W-6 UPPER SEGMENT: HWY 90 TO SW MILITARY DRIVE SEWER MAIN PROJECT
Solicitation Number: CO-00317
Job No.: 19-4519

ADDENDUM 6
April 9, 2020

RESPONSES TO QUESTIONS

SHAFT #2 (PEARSALL SHAFT) - SECTION I

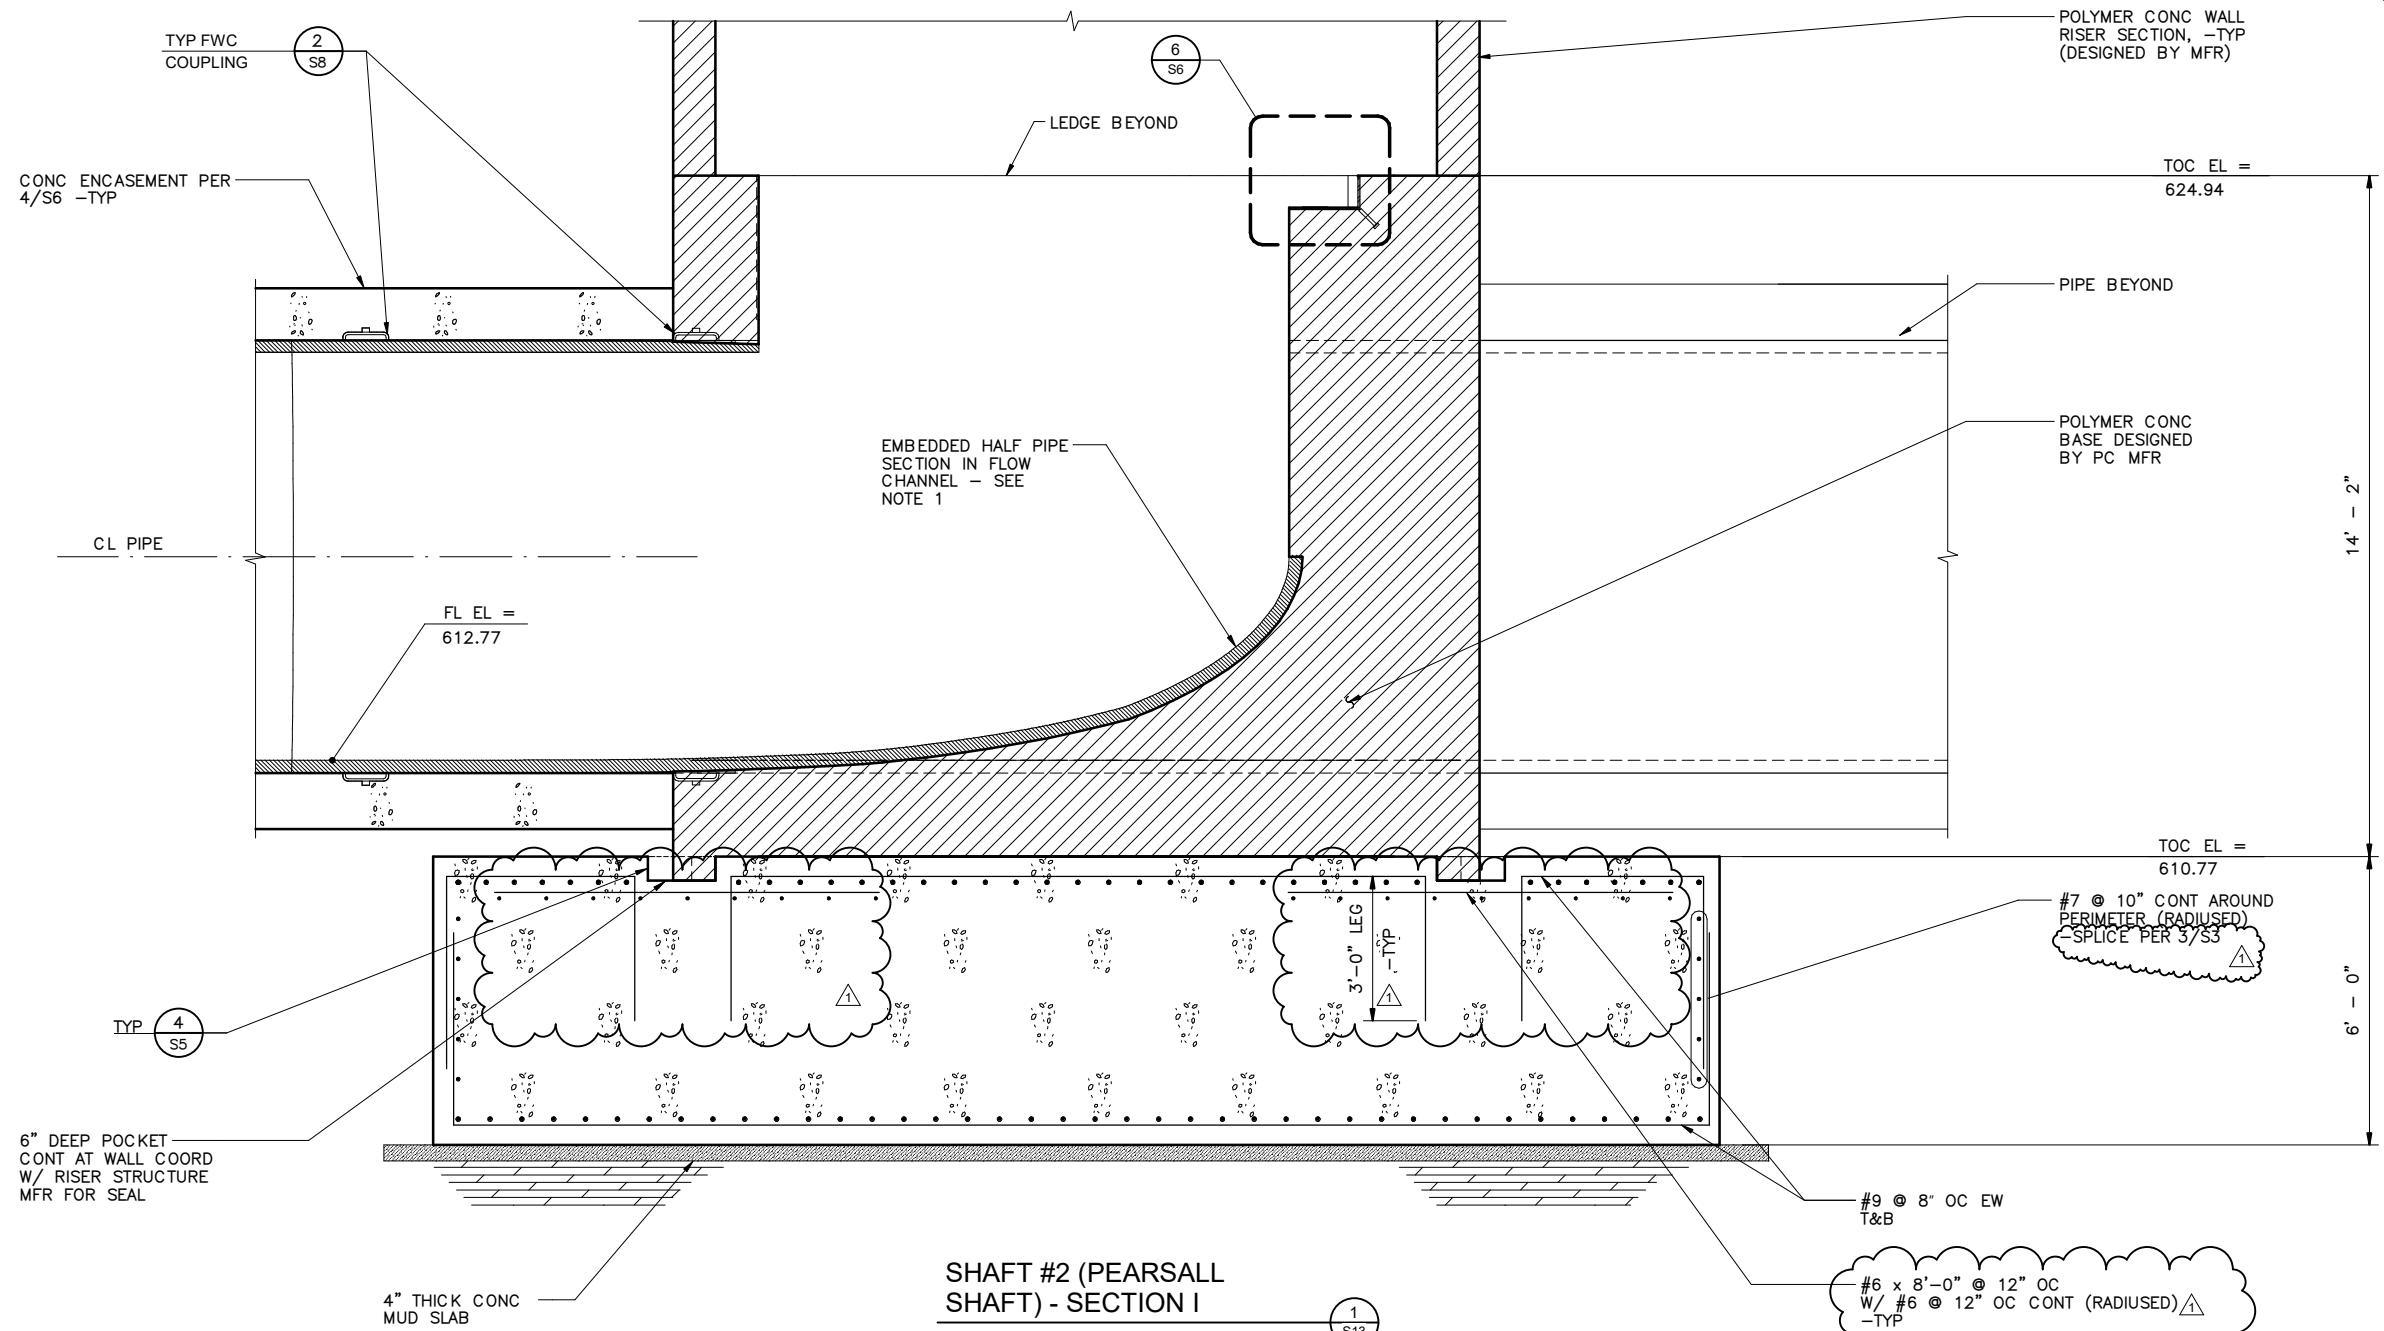
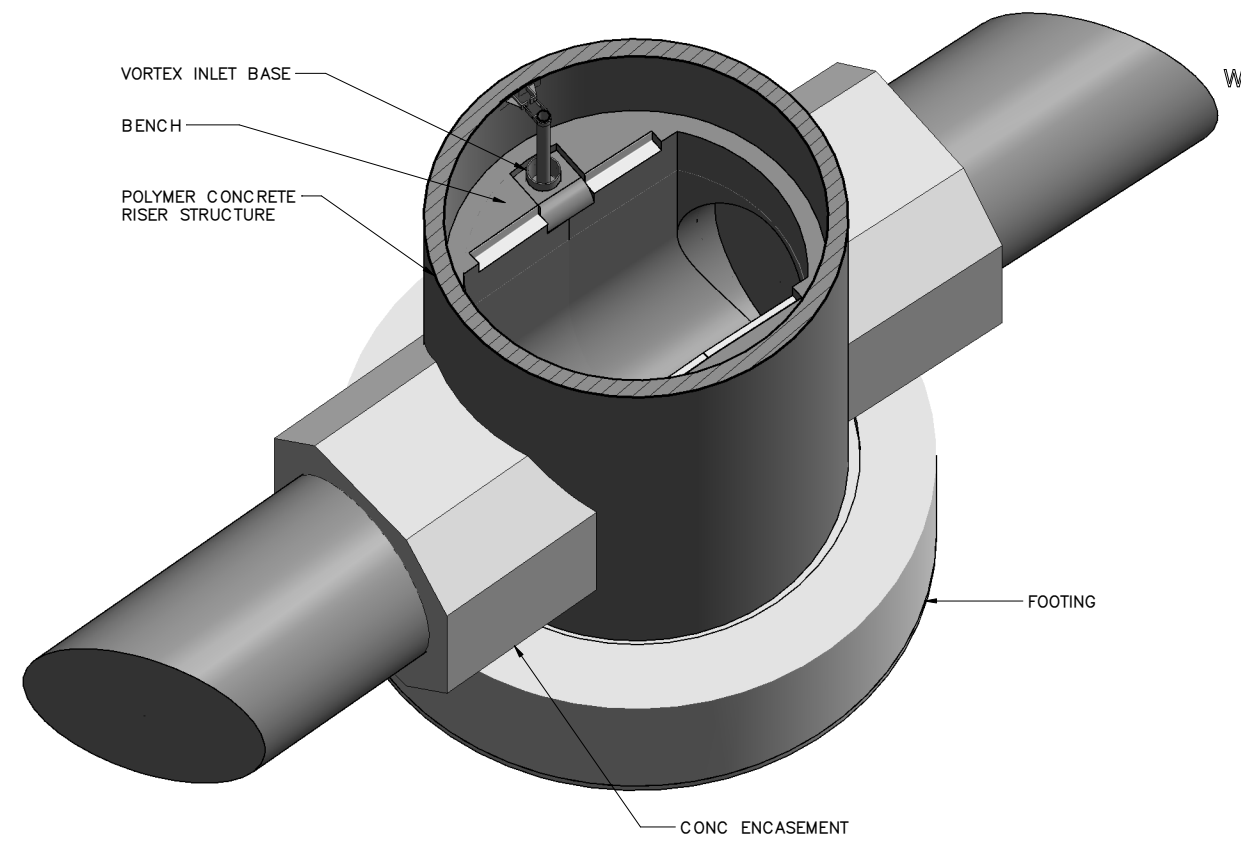
Q71: Addendum No. 1 mentions that Sheet S14 was revised and replaced, however no revised sheet was included in the addendum. Please provide revised Sheet S14.

- Delete dimension between edge of foundation slab and the inside face of temporary shaft that reads “~3'-10” “.
8. Sheet S14 – Shaft #2 (Pearsall Shaft) – Section II:

- Section 1 – Add reinforcement callouts as shown on the revised drawings.
9. Sheet S16 - SHAFT #3 (MERRY OAKS SHAFT) – LOWER LEVEL PLAN AT EL 616.99' - Revise the sheet as below.

Response: *Sheet S14 was revised per Addendum No. 1 and is attached to this addendum.*

<p>W-6 UPPER SEGMENT: HWY 90 TO SW MILITARY DR</p>	
	<p>SHAFT #3 (MERRY OAKS SHAFT) - LOWER LEVEL PLAN AT EL 629.16'</p>

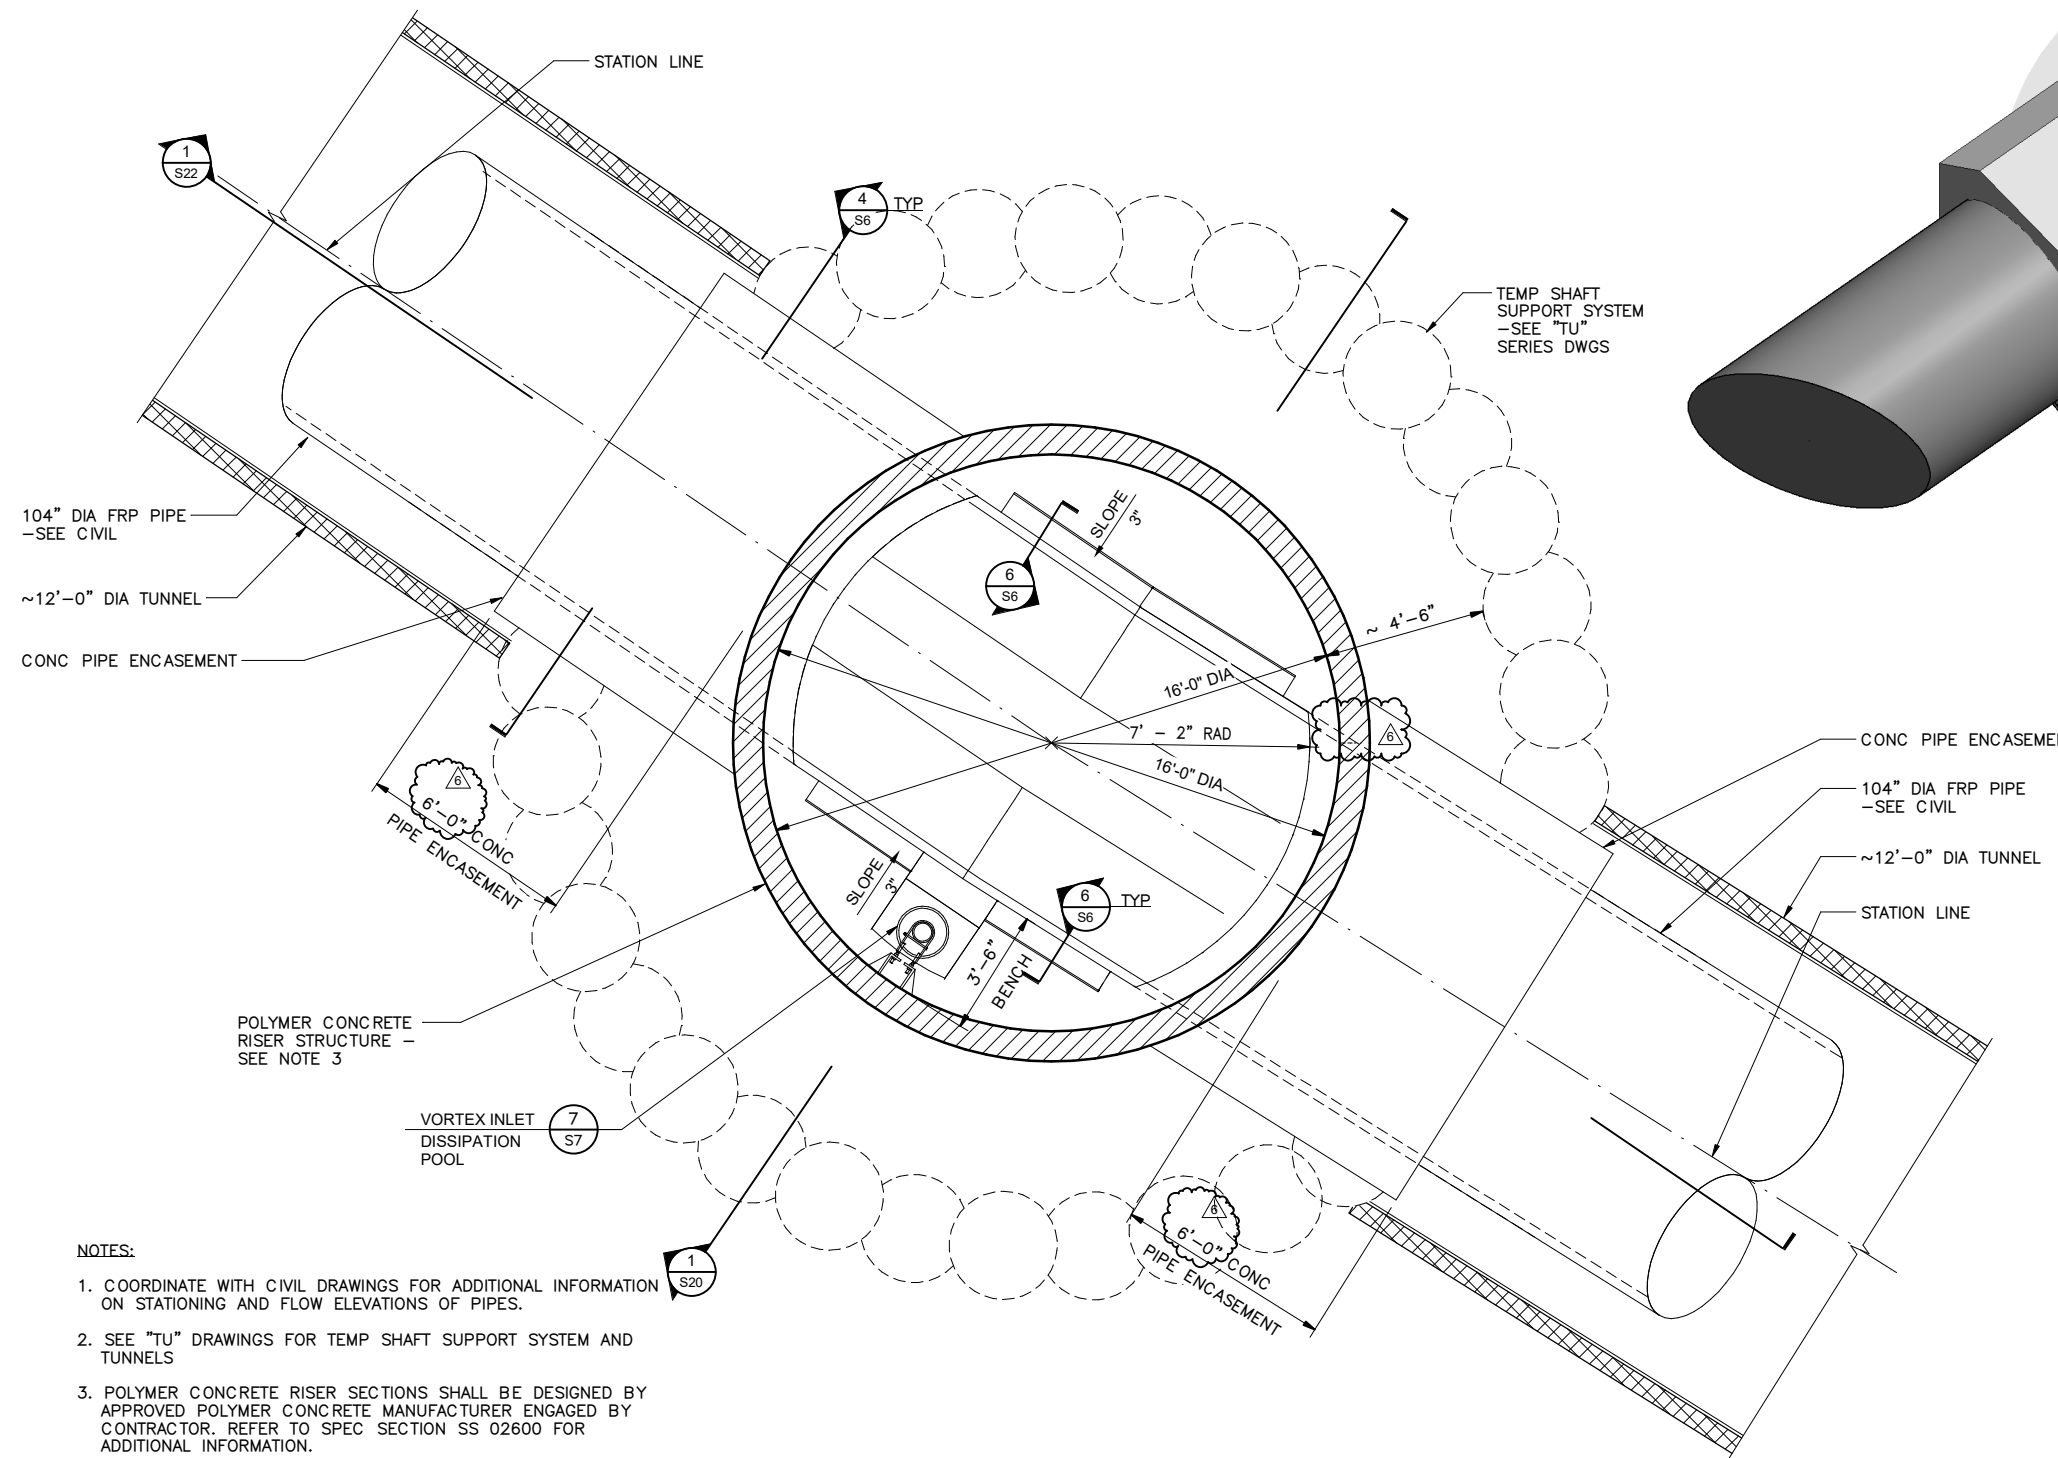
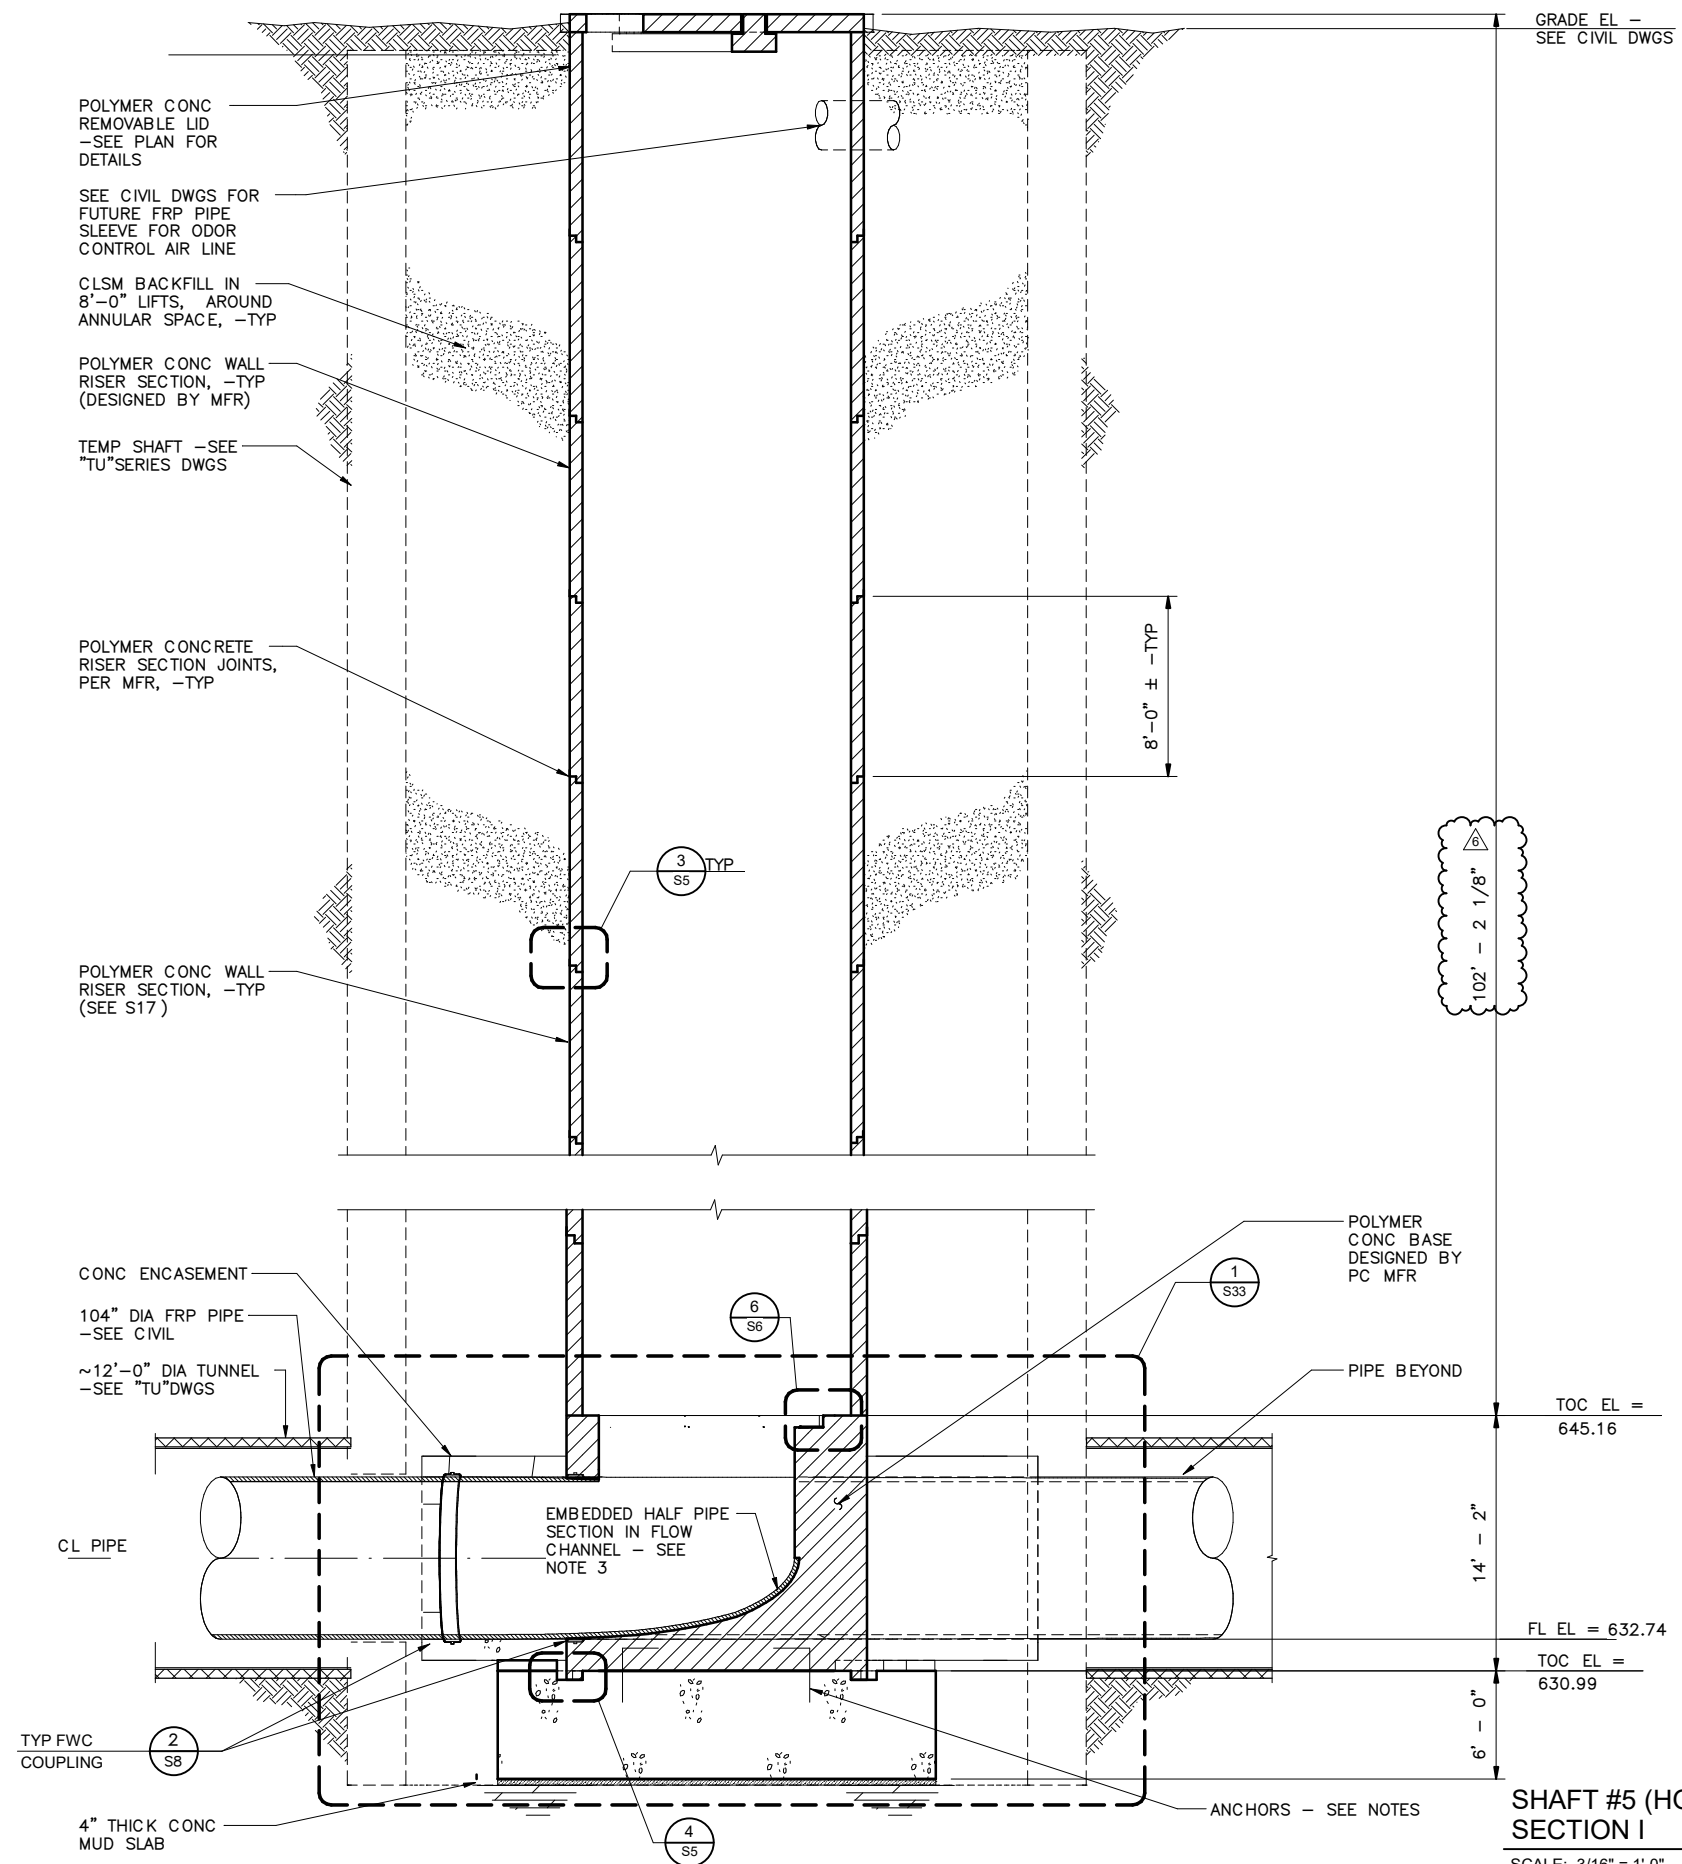
Q38: Sheet S16, S17, and S22. Dimension clarification.

Question: On Sheet S16 & S22 pipe encasement is 6'-0", but on Sheet S17 pipe encasement is 6'-10". Is the intent for the polymer concrete structure wall to be 5inches thick? Please confirm dimension. This is repeated on Water Tower Shaft details as well.

- Add dimension call out for the diameter of the foundation slab that reads “25'-0” Dia (min)”
10. Sheet S17 - SHAFT #3 (MERRY OAKS SHAFT) - UPPER LEVEL SLAB PLAN AT EL 629.16' - Revise and replace the sheet in its entirety.

- Revise length of pipe encasement call out to read “6'-0” ” as shown on the revised sheet at two locations.
11. Sheet S23 - SHAFT #4 (WATER TOWER SHAFT) – LOWER LEVEL PLAN AT EL 622.25' - Revise the sheet as below.

Response: *Encasement length shall be 6-ft from the exterior face of the riser. Thickness of the Polymer Concrete Riser shall be designed by the PC manufacturer.*
